Application Number:	PL/2026/05002
Location:	Car Park North of The New Inn, Semington Road, Berryfields, Melksham, SN12 6DT
Proposal:	Outline permission with some matters reserved for Proposed 3 New Dwellings & Alteration of Existing Car Park (access only)

Introduction and Proposal

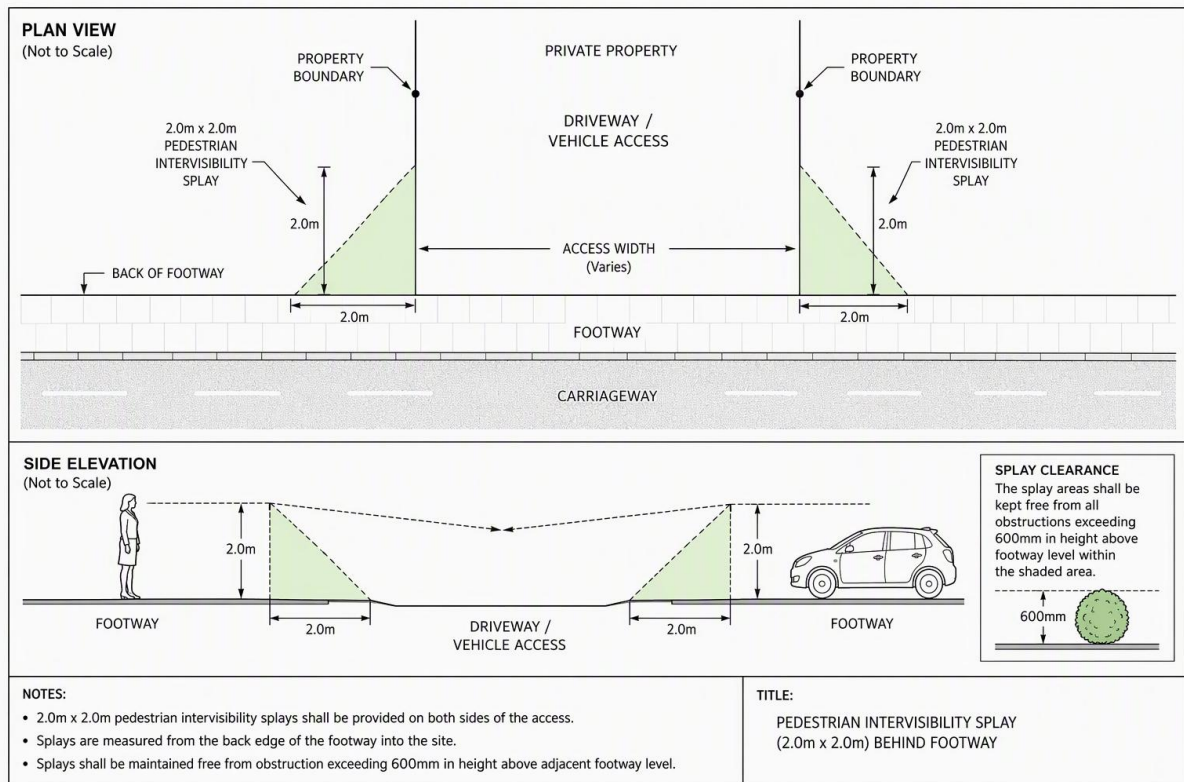
The proposed access serving the retained public house car park would be located in the position of an existing pedestrian crossing facility comprising dropped kerbs and tactile paving associated with pedestrian movements between the Village Hall and the opposite side of Semington Road. The loss of, or interference with, this established crossing point would not currently be considered acceptable. The applicant should demonstrate how pedestrian connectivity and crossing facilities would be retained or appropriately reprovided.

The accesses should incorporate pedestrian intervisibility splays, in accordance with the following detail.

The submitted plan, however, indicates splays of 2.4m by 40m which falls marginally short of the recommended requirements. The applicant should submit an amended plan demonstrating the full visibility splays required.

However, the intended means of access to serve the retained car parking for the pub is not acceptable in its proposed location due to conflicts with the existing pedestrian crossing point.

In order to provide adequate space for parking and for rear access to the dwellings, 3m wide driveways should be provided (6m for the double driveway), which would provide appropriate access to the rear garden and provision for cycle storage sheds in the rear gardens.

The driveway parking bay widths should be a minimum of 3m to provide sufficient access for vehicles and access to the rear gardens, within which bin storage and cycle storage would be expected.
